# **MONITORING YEAR 5 ANNUAL REPORT**

## **AGONY ACRES MITIGATION SITE**

RE: Monitoring Year 5 Report for Agony Acres Mitigation Site (95716)  
Cape Fear River Basin (03030002)  
Guilford County, North Carolina  
Contract No. 004949

We have reviewed the comments on the Monitoring Year 5 Report for the above referenced project dated November 7, 2019 and have revised the report based on these comments. The revised documents are submitted with this letter. Below are responses to each of your comments. For your convenience, the comments are reprinted with our response in italics.

### Recorded In-Stream Flow Events

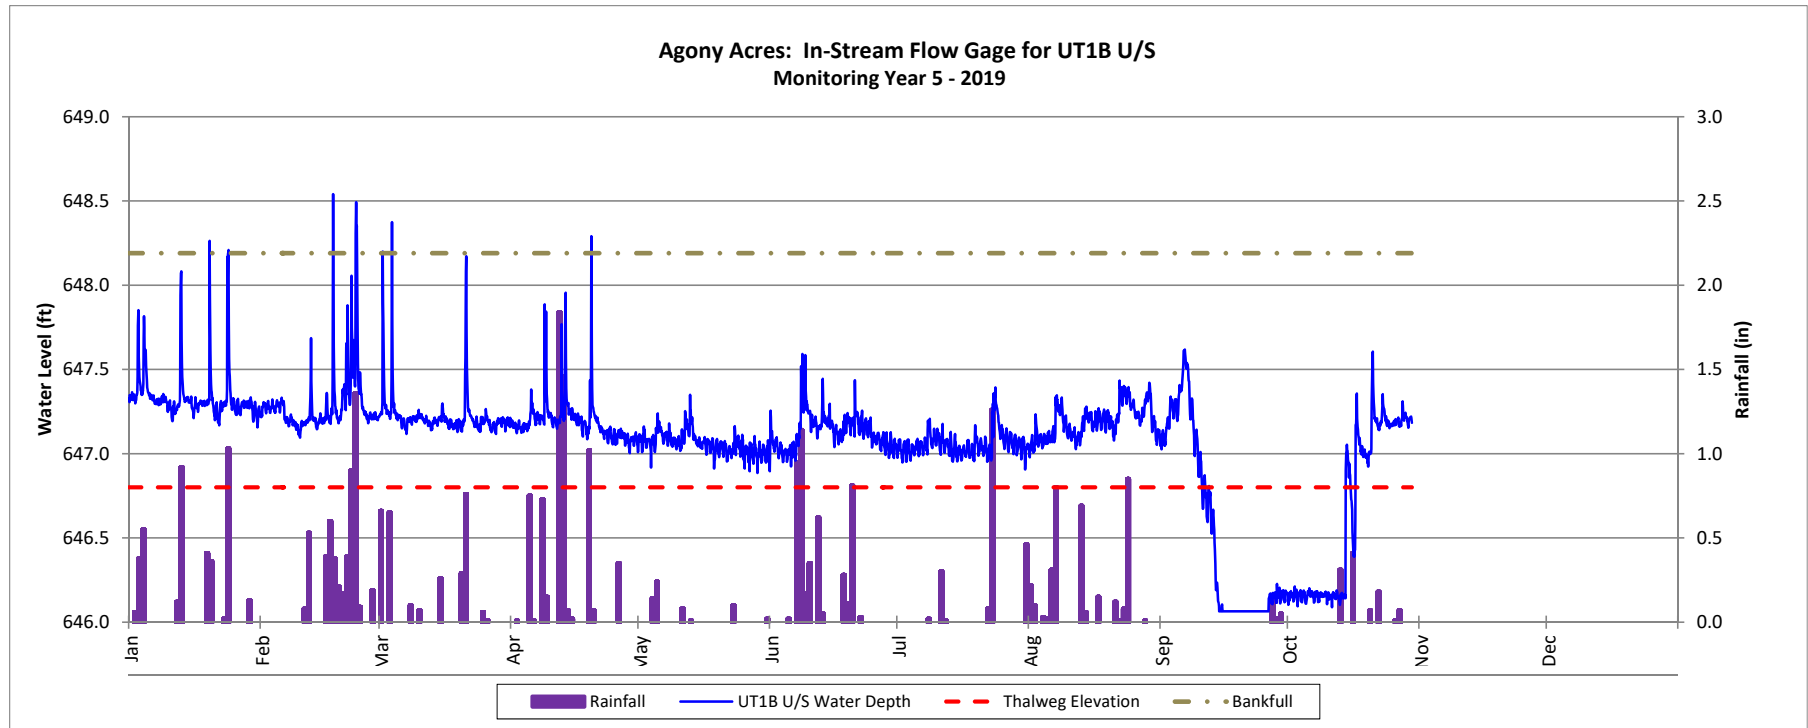
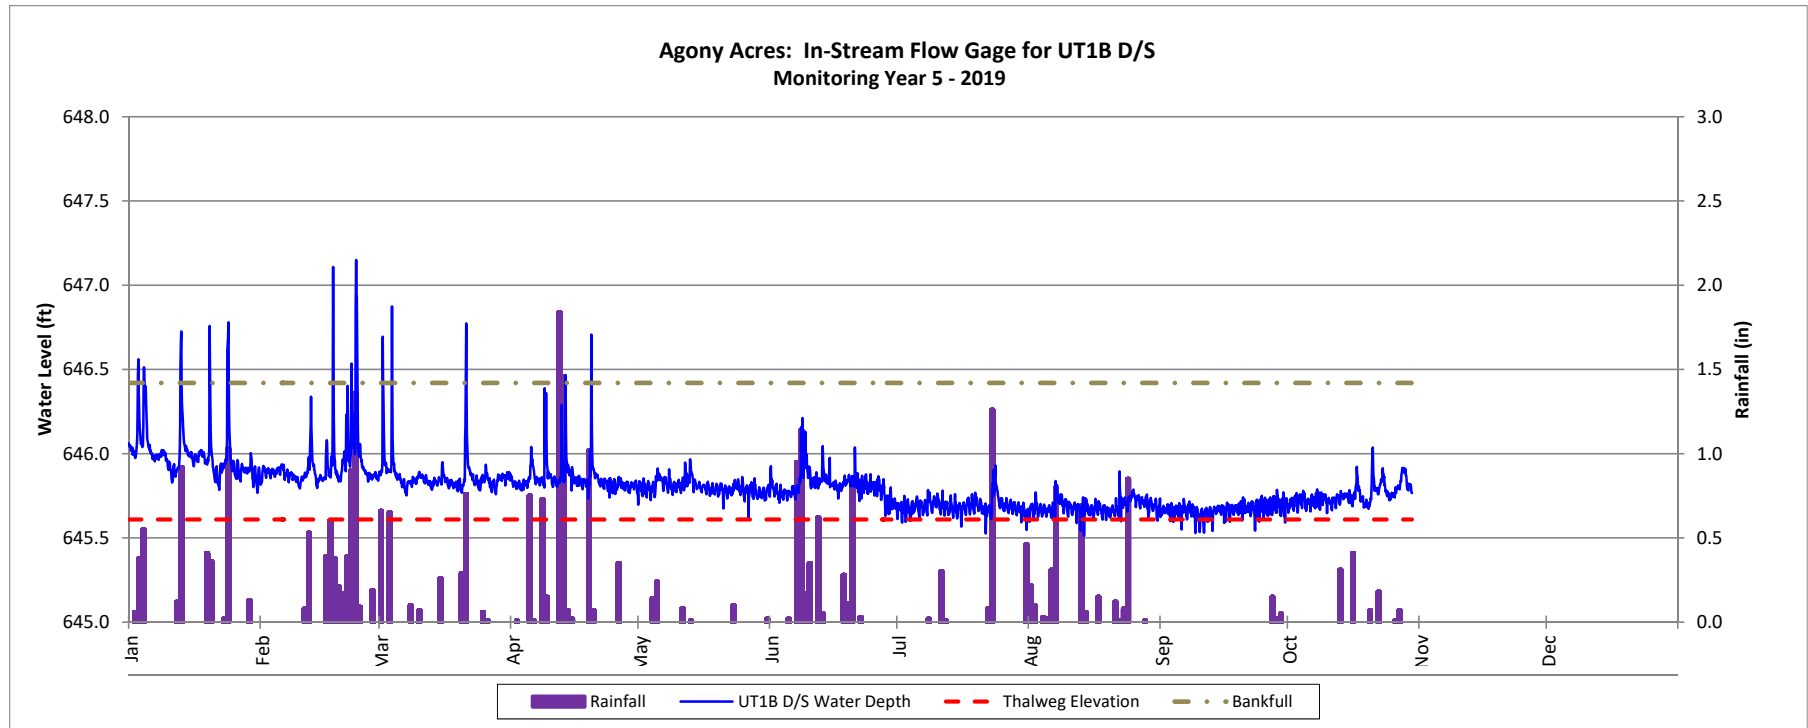
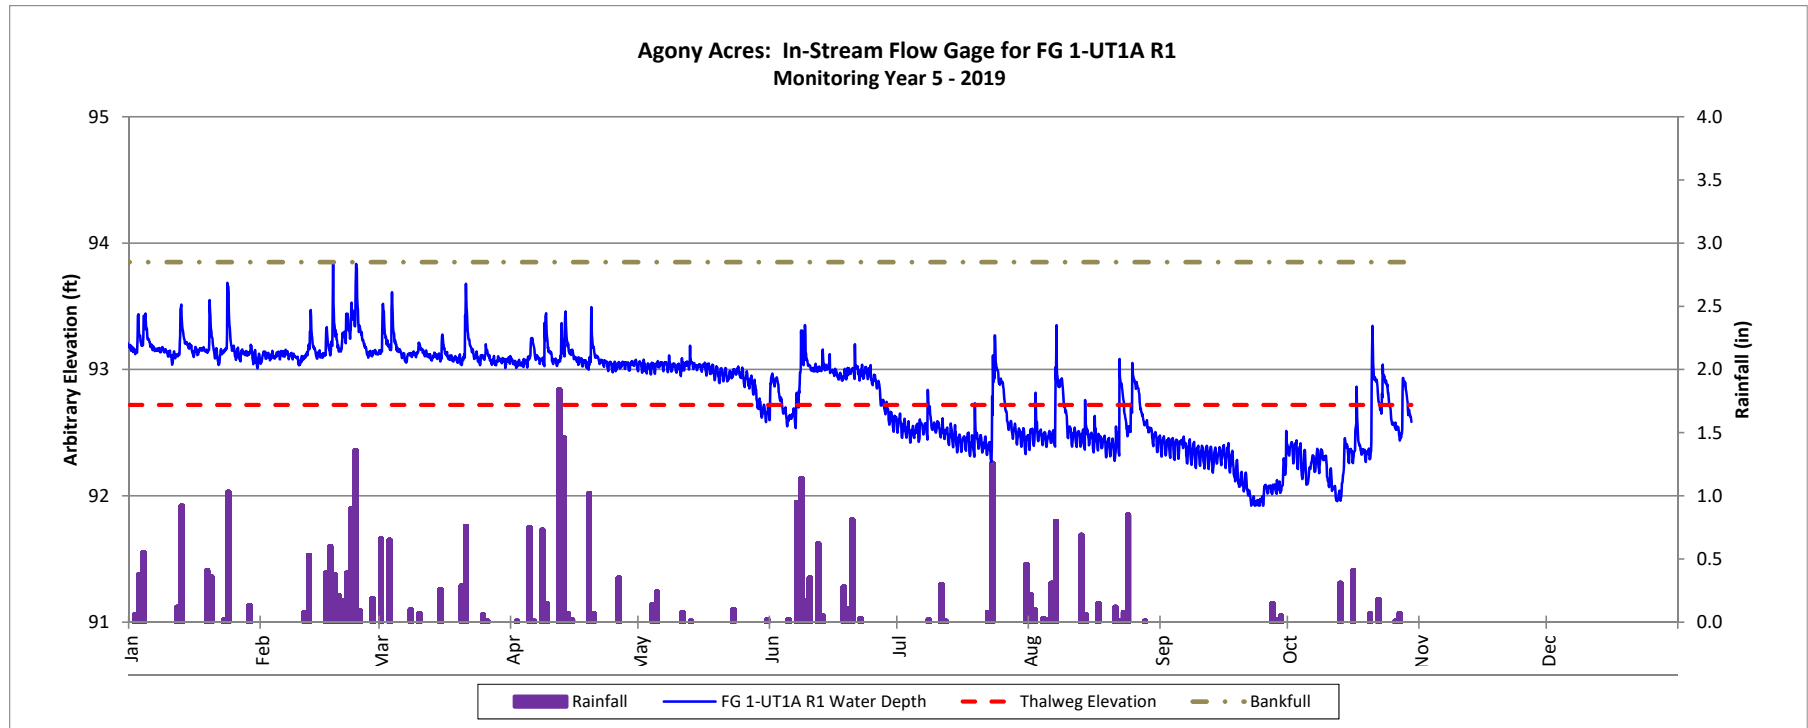
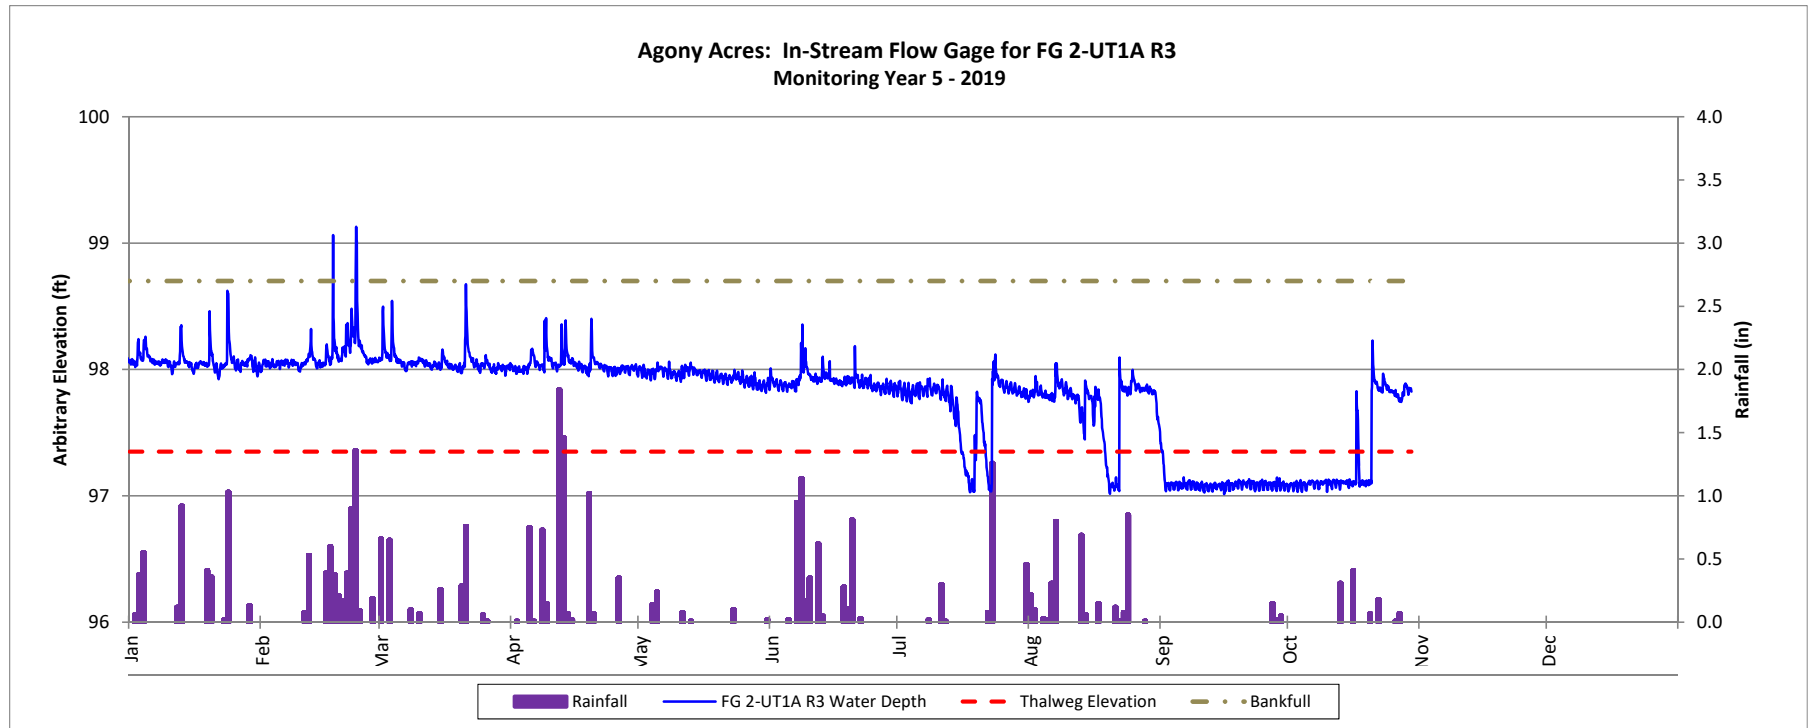
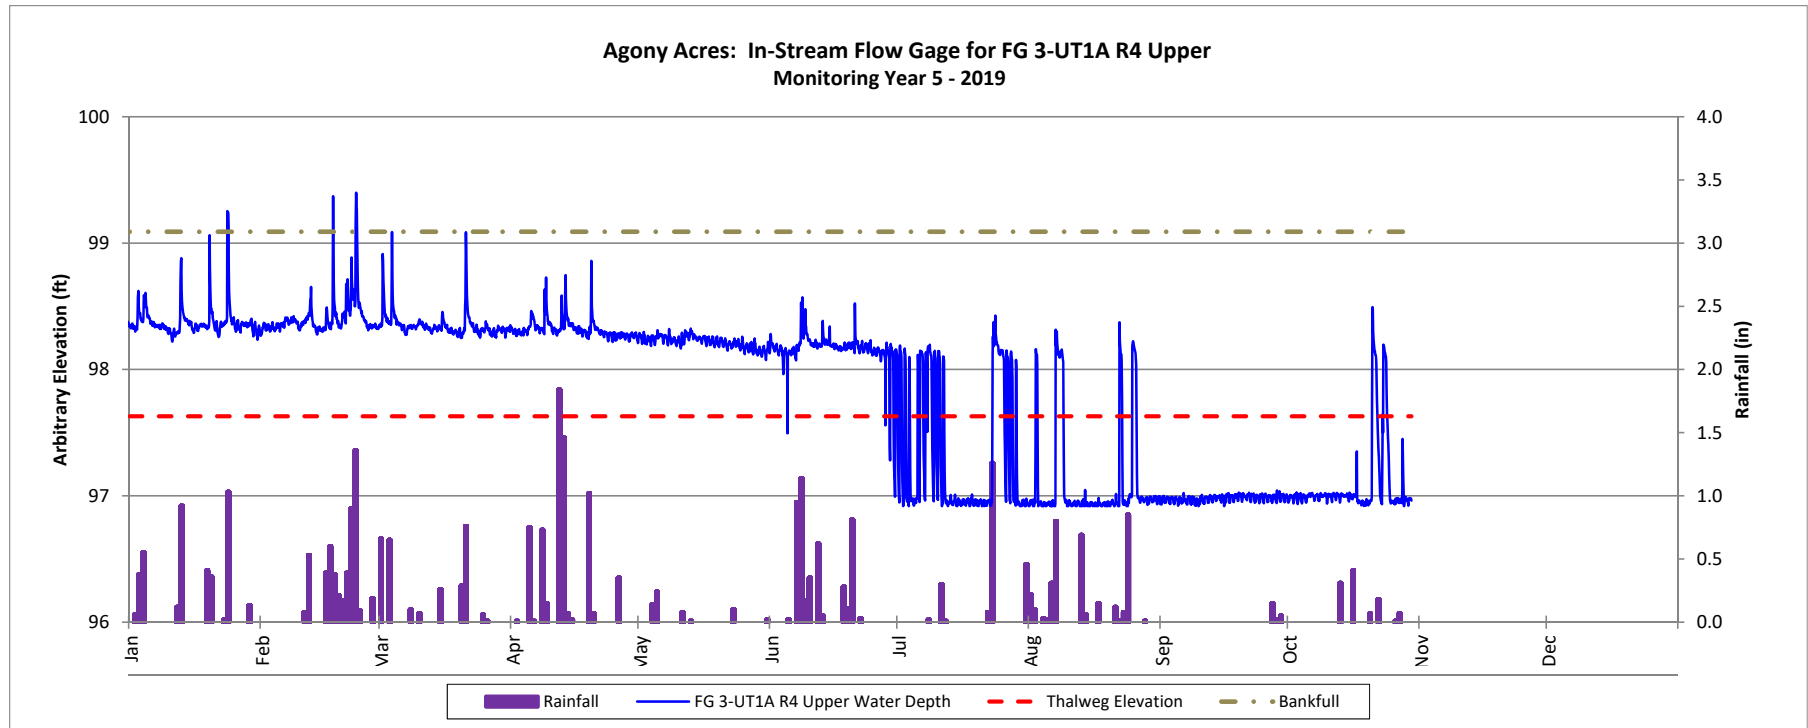
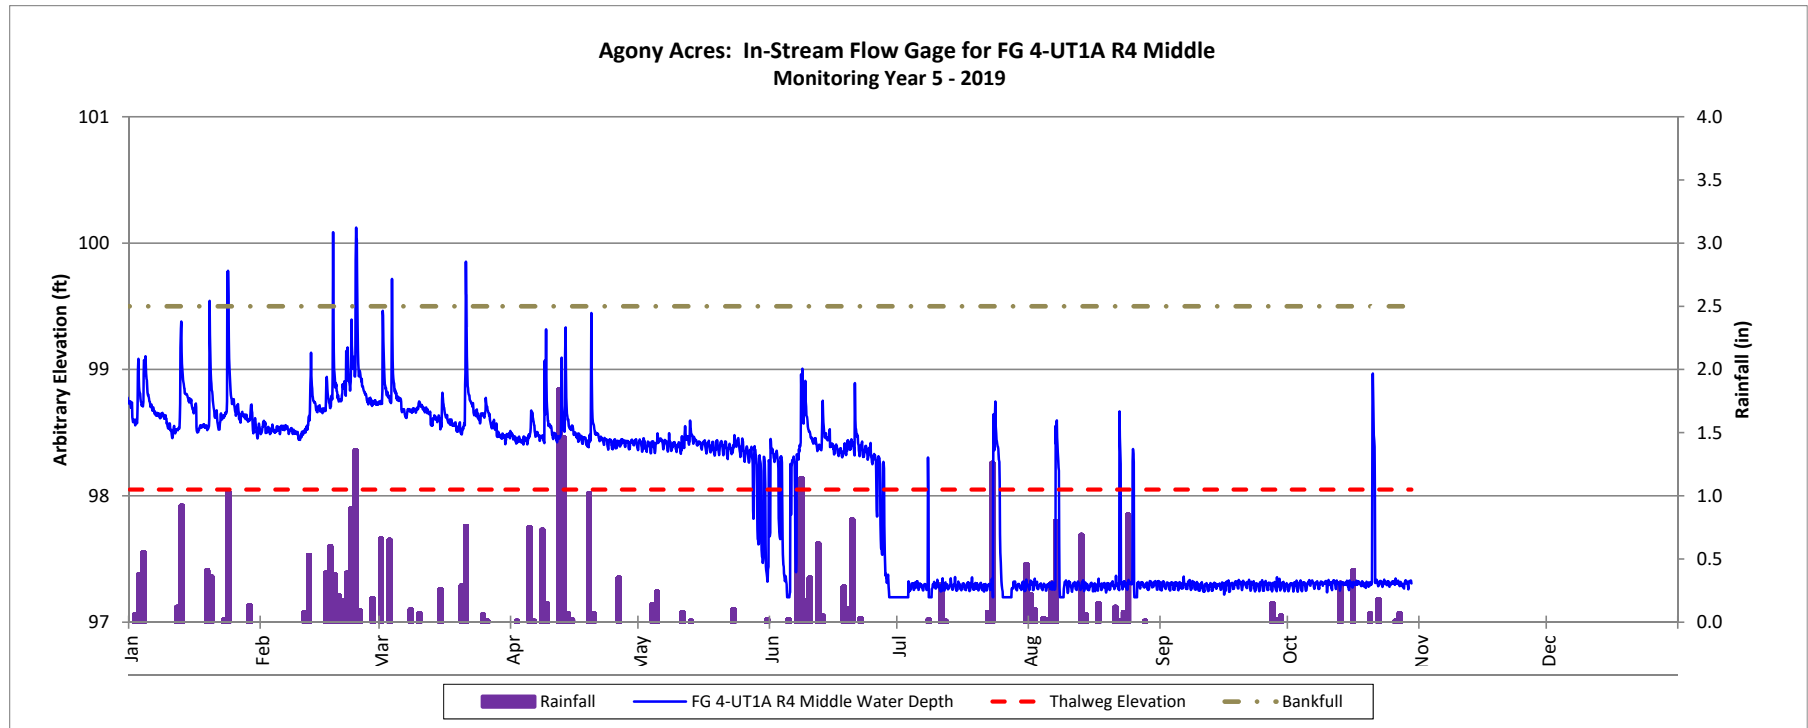
5. Appendix 5

Please add flow gauge data for UT1A.

*UT1A flow gauge data has been added.*
